SUBJECT: VOIDED APPLICATION  
Abandoned

Control Number: 112158

Applicant: Iodo Products, Inc.

This is in reference to your application dated March 2, 1990, for a byproduct material license. In order to continue our review, we need the following additional information:

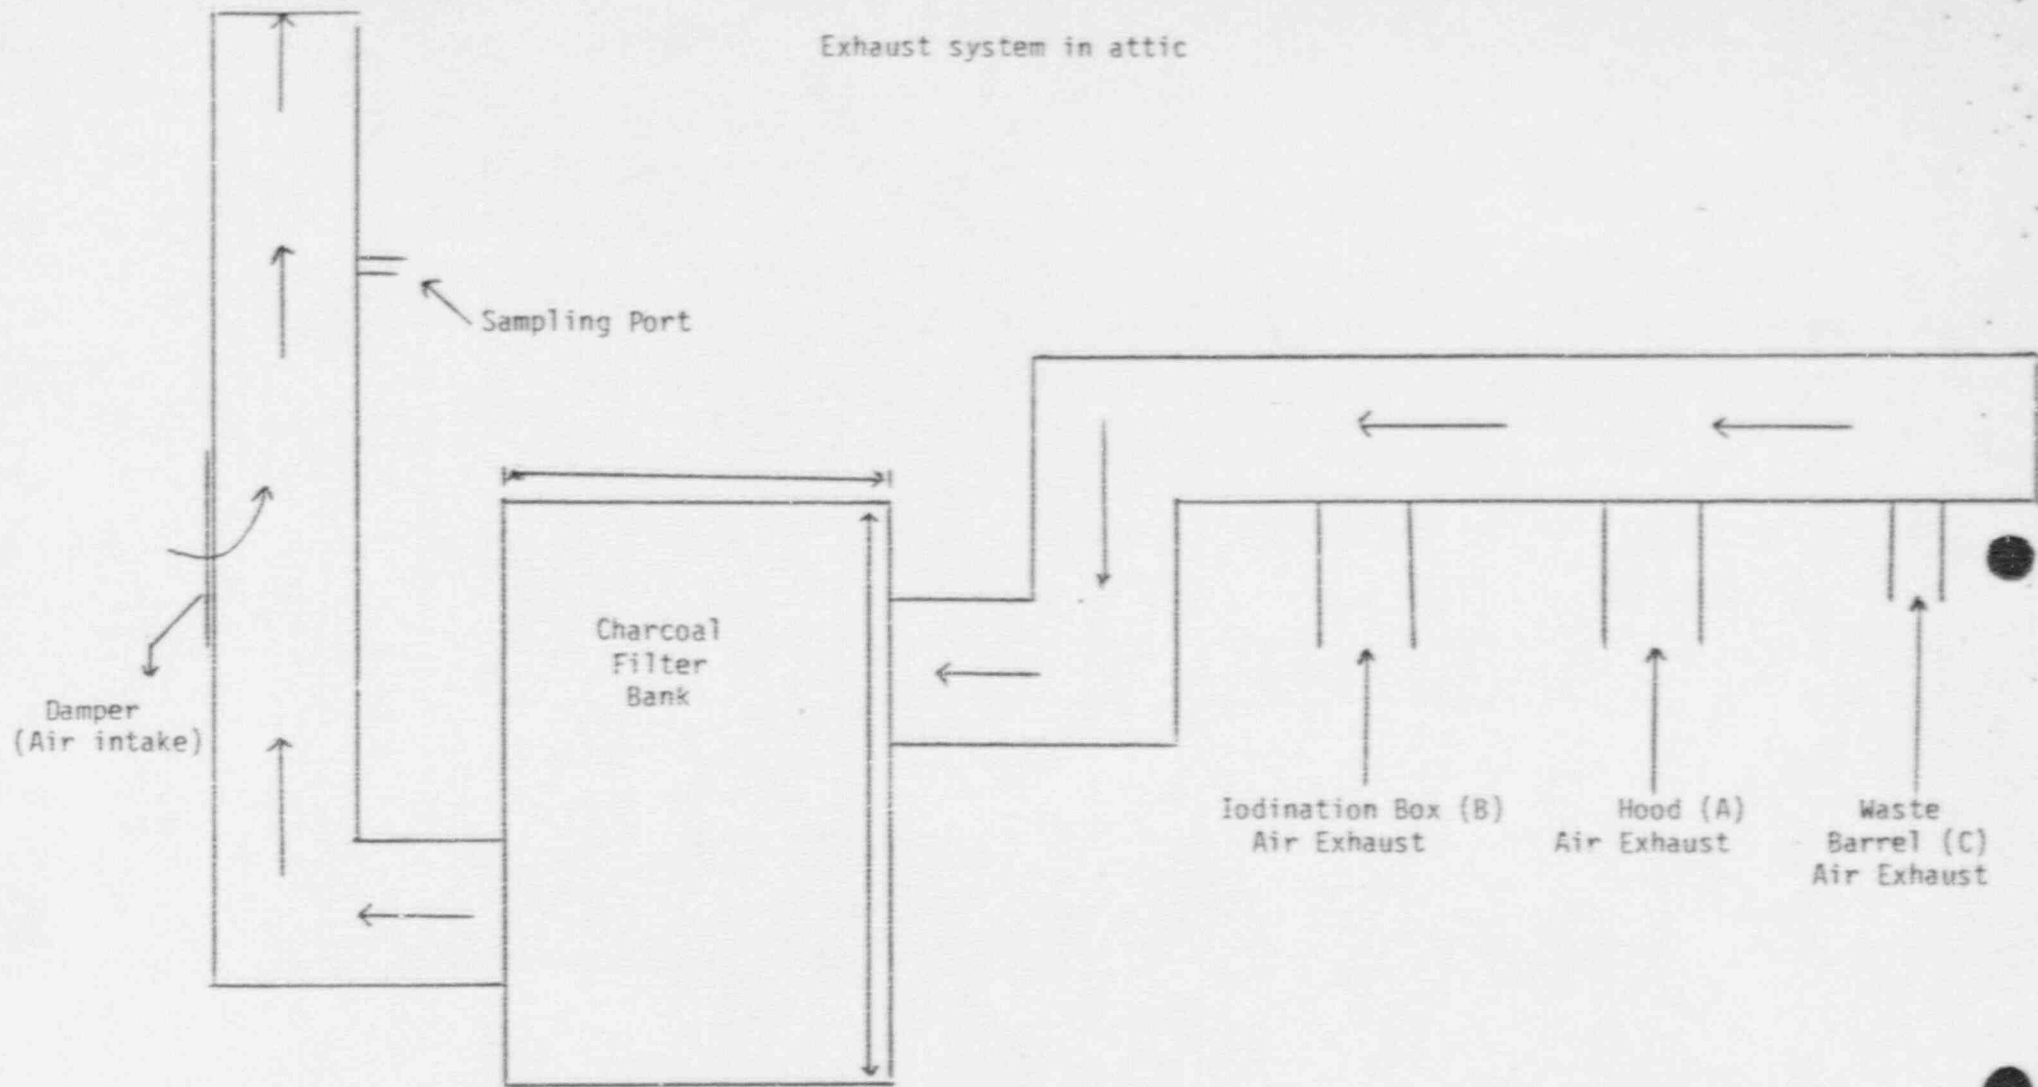
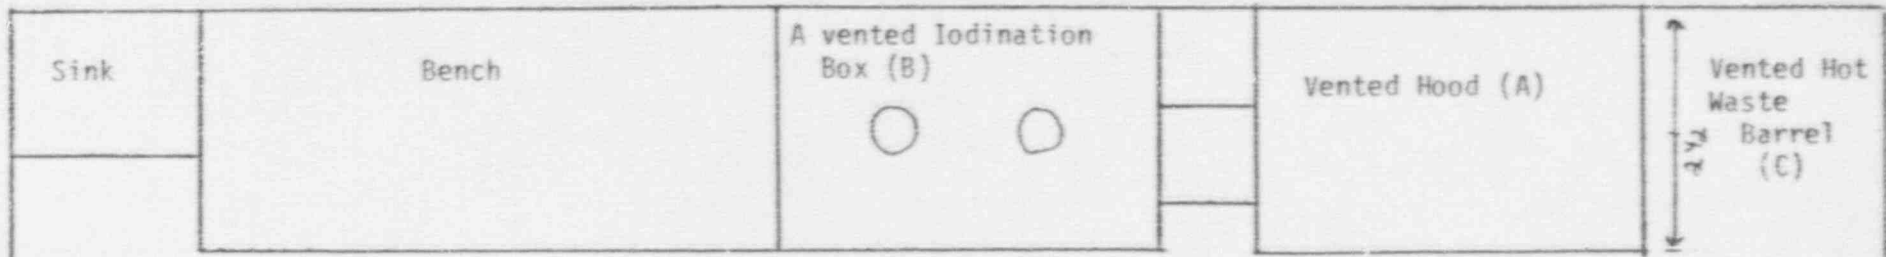
4. Please describe the method and frequency for testing the face velocity of your hood.
5. Your equipment should include a survey instrument with a NaI detector probe to detect I-125 contamination. Please specify the instrument that will be used for this purpose.

- l) Secure all radioactive material when not under the constant surveillance and immediate control of the authorized users.
9. In your application, you did not indicate how you will secure licensed material (10 CFR 20.207). Please specify how you will preclude the unauthorized removal of licensed material from the place of storage.

- a. 1. See attached diagram
2. The laboratory will be designated as a hot laboratory with one entrance. The entrance will be through the change area which will be equipped with a monitor.

3. Material received and finished products will be checked for contamination.
4. The starting material and finished products will be stored in a vented hood (A) see diagram.

5. Starting material will be processed in a vented iodination box (B) behind lead bricks.
6. Iodination box will have negative pressure and air will enter from the hood. Iodination box will be totally sealed.

7. Iodination box and hood and waste barrel (C) will be connected and the air will be exhausted through a charcoal filter.
8. Air flow through the hood (A) will be approximately 100 cu ft/minute.

9. The hood face will have approximately one square ft. opening.
10. Exhaust air from the iodination box will be approximately 80 cu ft/min. and hood exhaust air will be approximately 20 cu ft/min.

11. The entire "hot" laboratory will be under negative pressure.
12. Air will enter only through laboratory door.
13. Exhaust fan will operate 24 hours, 7 days a week.

14. Before exhausting air into the environment, air samples will be collected continuously in a charcoal trap.
15. The laboratory will process only a maximum of 100 mCi Na <sup>125</sup>I and 50 mCi Na <sup>131</sup>I respectively at any one time.

16. The laboratory wall, floor and ceiling will be covered with impregnable color coating.
17. A reaction vial containing a syringed charcoal trap will be located in the primary box (D). This trap will collect free iodide present in the vial. The Berney-Chenny charcoal trap on top of the box (D) will also absorb free iodide. The Berney-Chenny trap contains a motor that will circulate the air within primary box. The remaining iodide will be absorbed by the charcoal filter bank located in the attic.

18. The entire exhaust air system for the laboratory will utilize a 2800 cfm rated fan. Exhaust flow from hot laboratory will be operated at a rate of 100 cfm. Make up air will be taken from the attic area, downstream of the charcoal filters and upstream of the exhaust fan. This air intake will be controlled by a damper. This should provide additional dilution of exhausted air from the laboratory.

19. A change area will be located adjacent to the laboratory door. The air will enter from the change area to the laboratory and through hood to outside.
